RE: DRAINAGE PLAN SUBMITTAL OF HIDDEN VALLEY IV-A OFFSITE FLOW
PROTECTION, RECEIVED JUNE 10, 1986 FOR DRAINAGE
IMPROVEMENTS APPROVAL (L-22/D13)

RE: Hidden Valley Phase 4A

HIDDEN VALLEY REVISED CHANNEL DESIGN

Re: Hidden Valley IV Channel

PLAN OF RUNDOWN

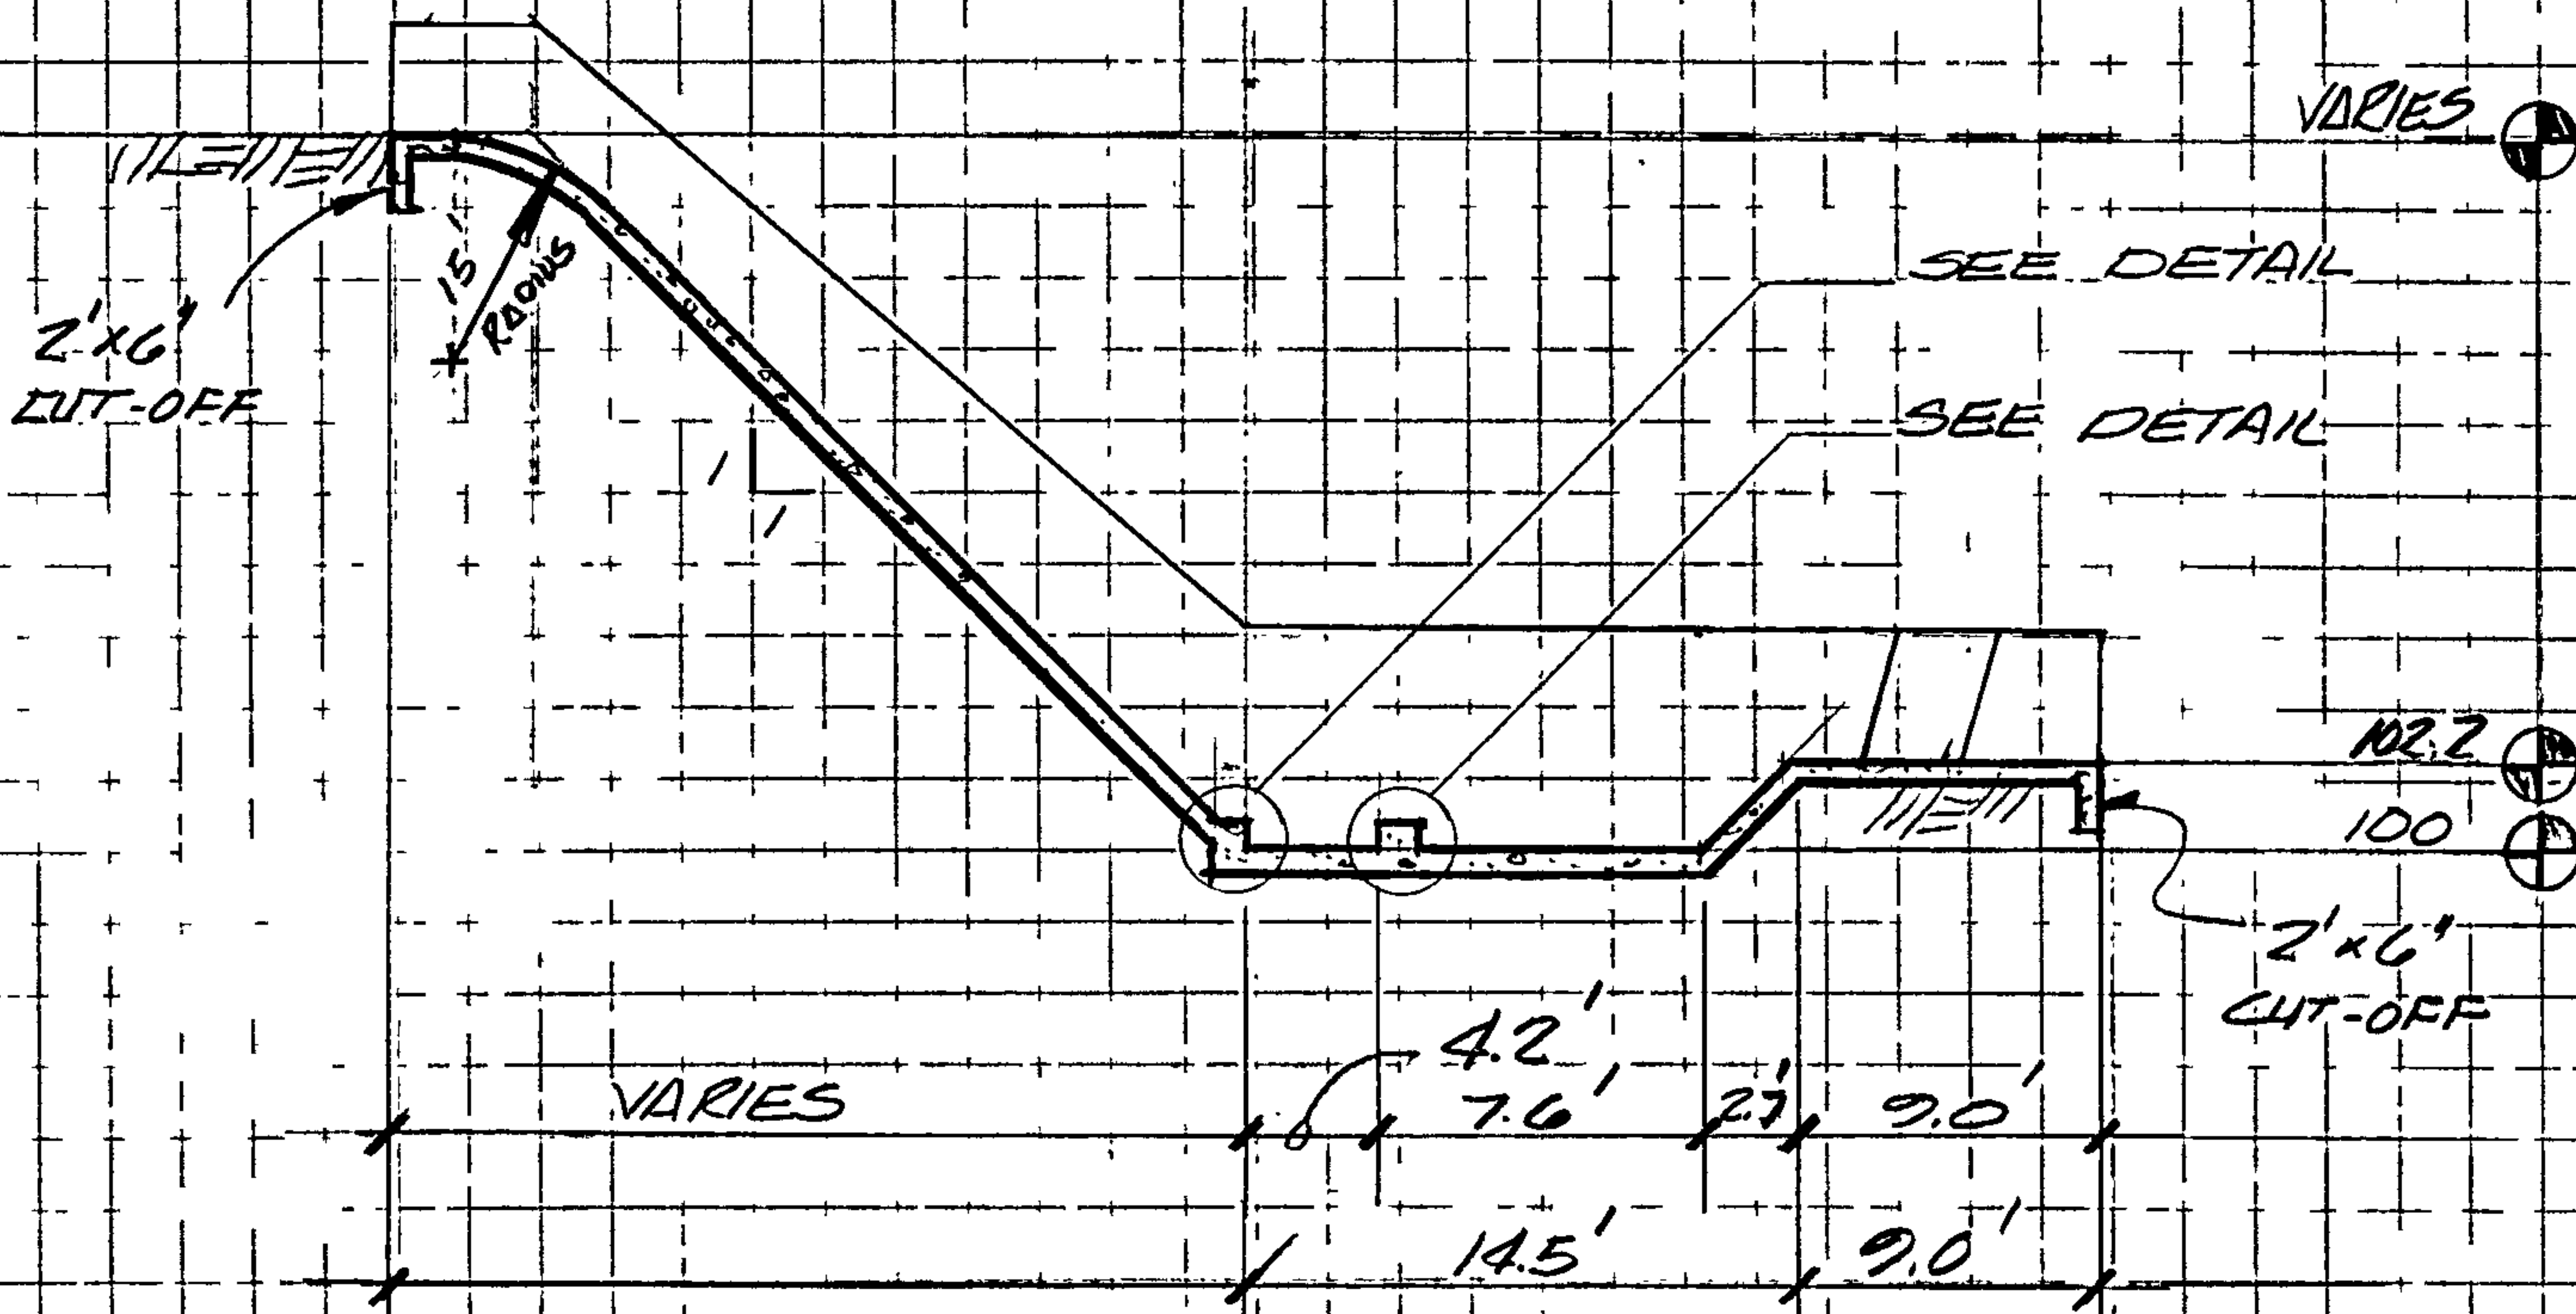
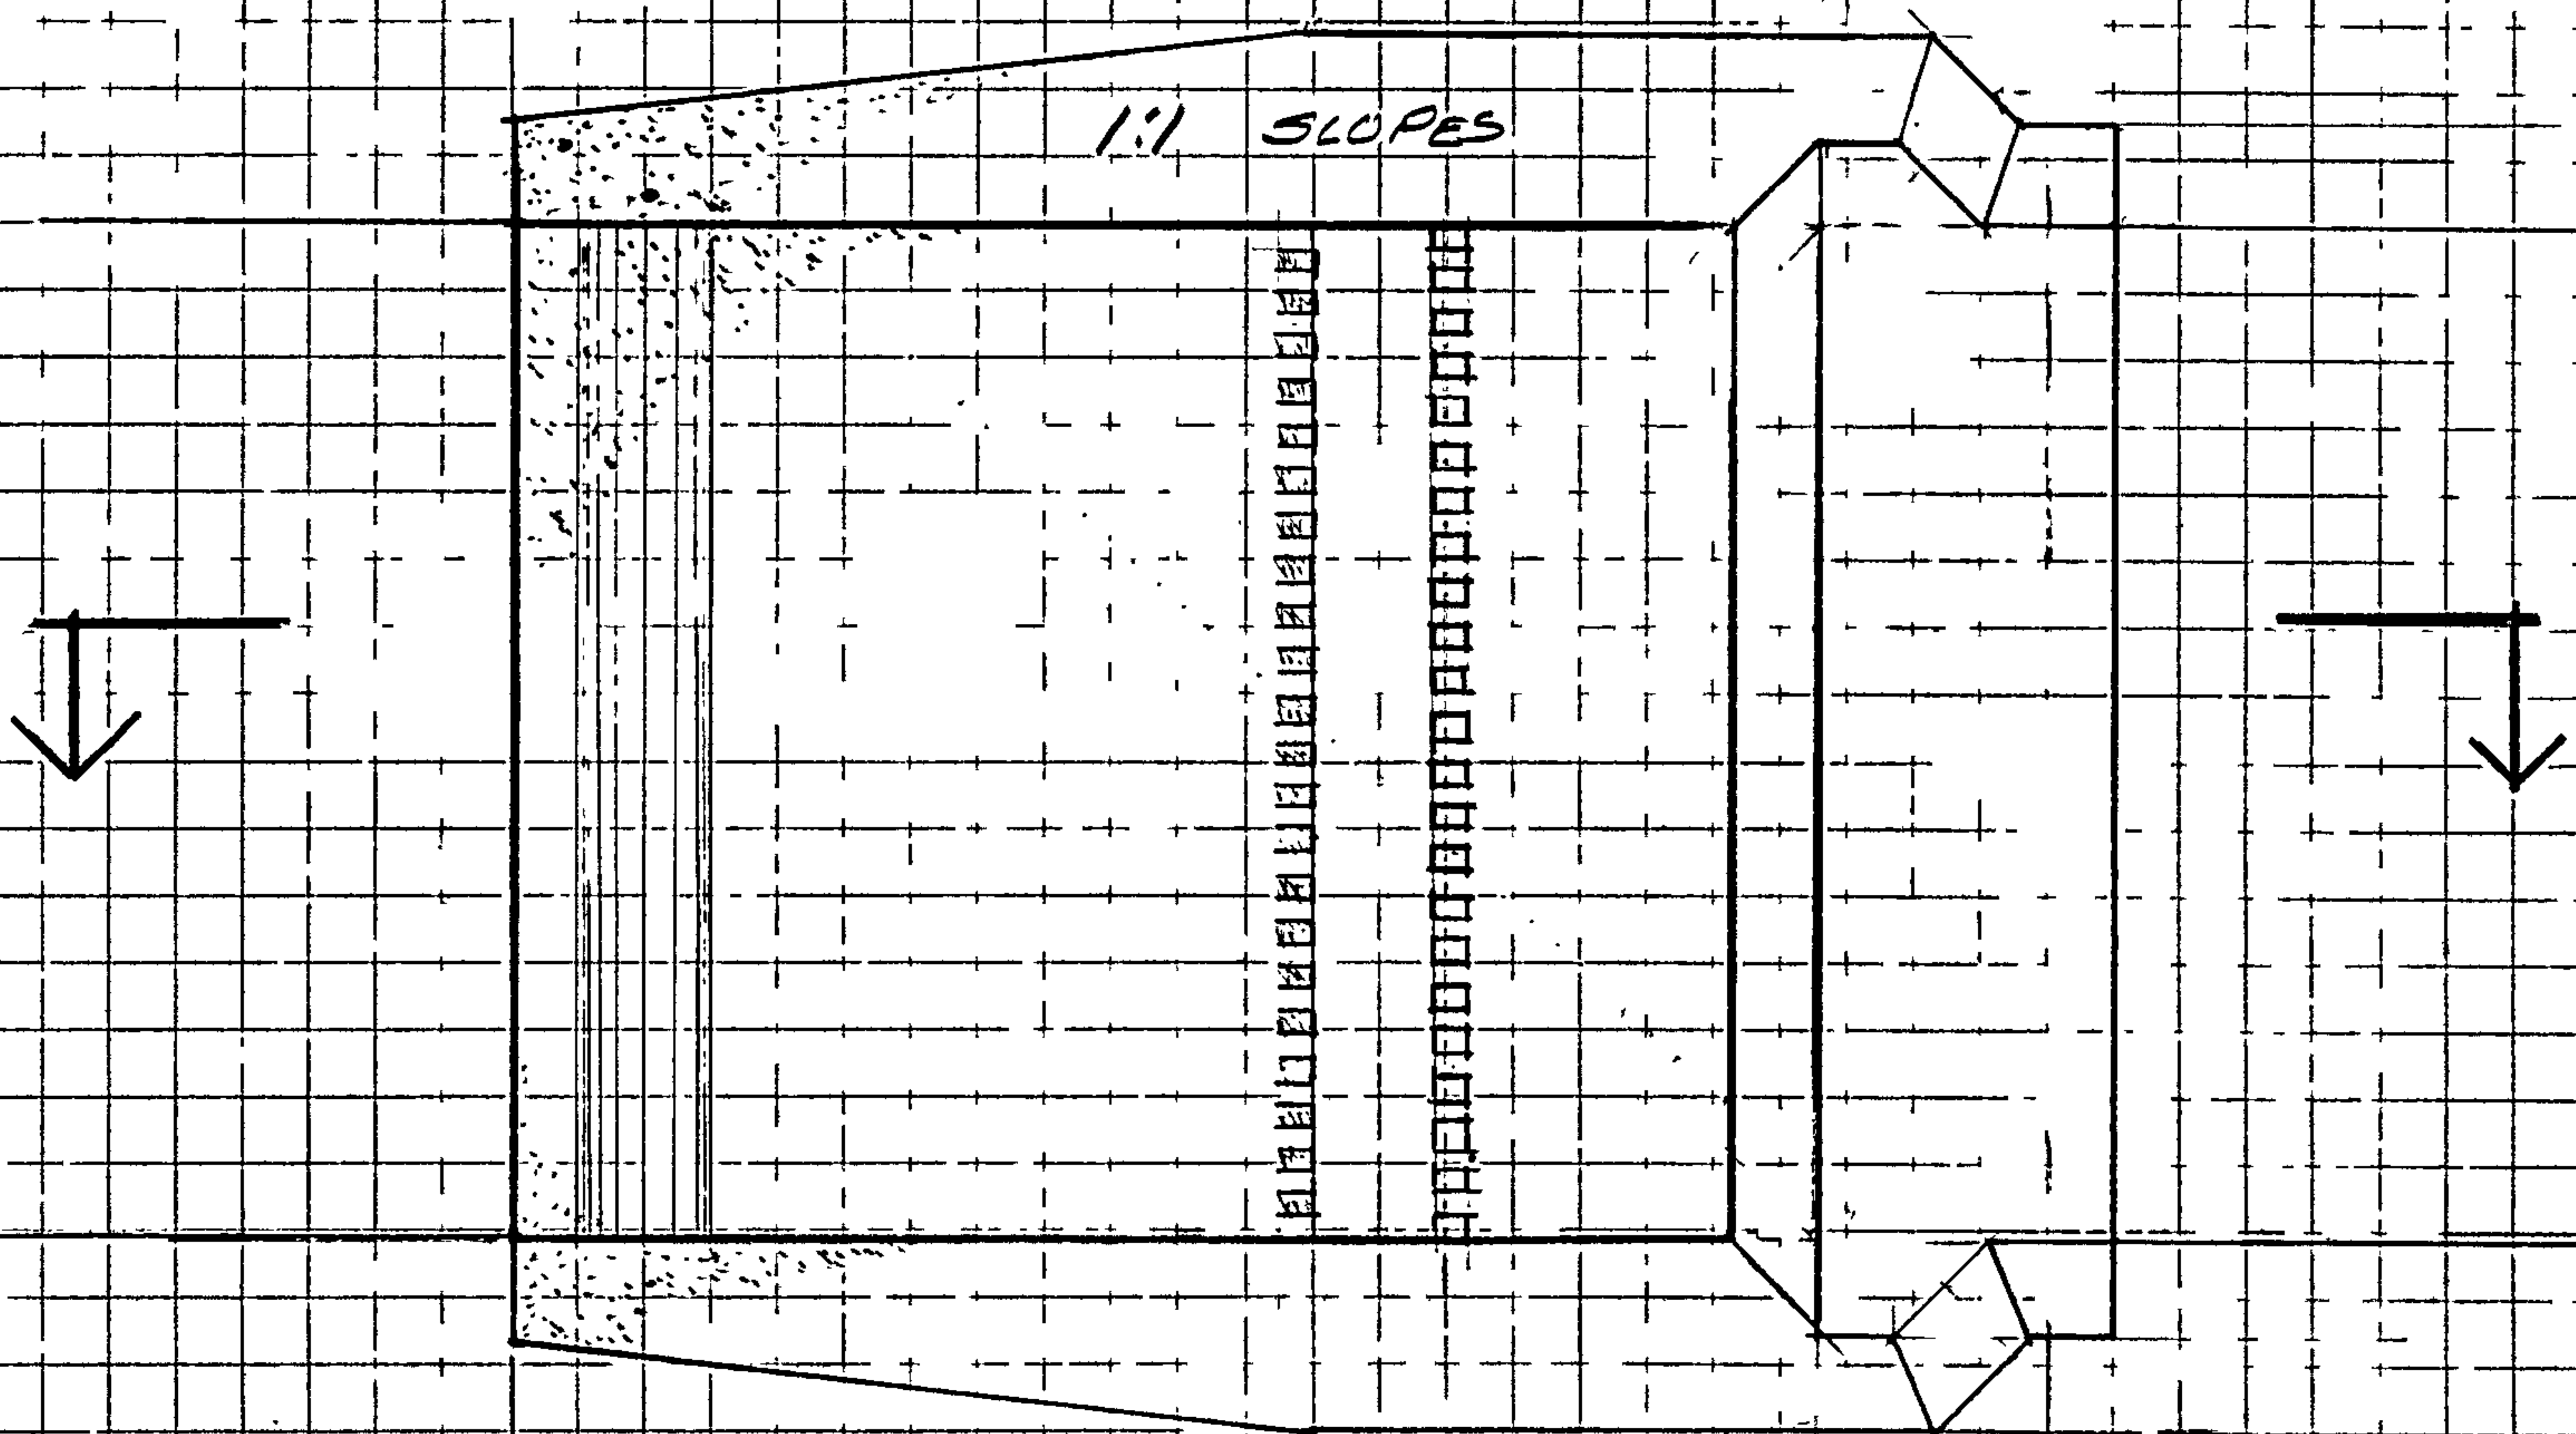
The design of the proposed drop structures does not appear to be adequate on several counts:

1. There is an abrupt discontinuity in the flowline at the entrance of the chutes. Negative pressure and cavitation of the concrete will result with the proposed configuration.

2. The proposed stilling basin is a hybrid not corresponding to acceptable configurations such as "Type II" or "Type III" U. S. Bureau of Reclamation stilling basins. A Type II basin which seems closest to the design submitted requires a stilling basin length of 20.0 ft. vs. the 9.5 ft. shown. As shown in the enclosed computations a Type III stilling basin (which in my opinion is the option of choice in this case) requires a minimum length of 12.6 ft.

3. The minimum tail water elevation required for Type III stilling basin is computed in 4.0 ft. while a Type II stilling basin requires a tail water depth of 4.6 ft. The proposed depth of flow in the downstream channel is given in 2.5 ft. This depth of flow is insufficient to confine the hydraulic jump within the stilling basin.

4. The flow down the chute needs to be laterally confined to insure the effectiveness of the baffle blocks. The cinder blocks embedded in the floor of the stilling basin would be receiving the impact of the flow travelling down the chute at 31.25 ft/sec. As such they receive the momentum of the water which must be transmitted to the reinforcing in the floor of the basin. The proposed solution is not acceptable.

5. A plannimetric representation of the stilling basin must be furnished to show that the chute blocks and the baffle blocks are offset as required in the design standards.

6. The drawing must show clearly that dissipation devices will be constructed at each drop structure.
